Office Action Summary	Application No. 10/566,639	Applicant(s) BONNER, MICHAEL R.
	Examiner LEONARD R. LEO	Art Unit 3785

DETAILED ACTION

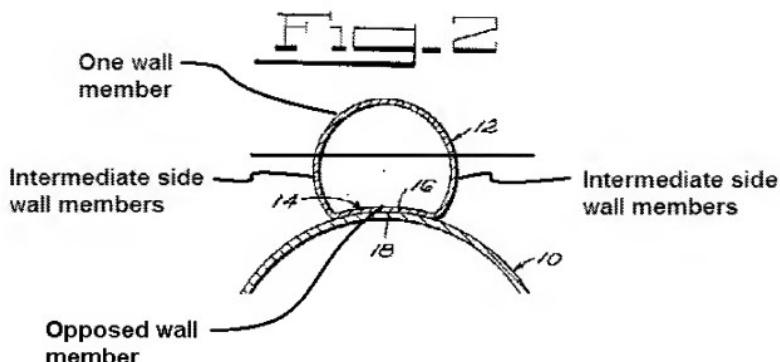
Collito (Figure 2, marked up, next page) discloses a conduit assembly comprising a fluid conveying conduit 10 and two conduit members 12 having an elongate, flexible fluid-tight wall having at least two opposed wall members, one wall member has a convex outer surface and an opposed wall member has a concave outer surface 16 and intermediate side wall members (i.e. delineated by the line) interposed there between and defining a non-circular cross section; but does not disclose a polymeric material and a rib/tab, nor the conduit members in contiguous contact with one another.

Regarding claim 21-22, Figure 2 of Collito discloses the first and second walls are arcuate.
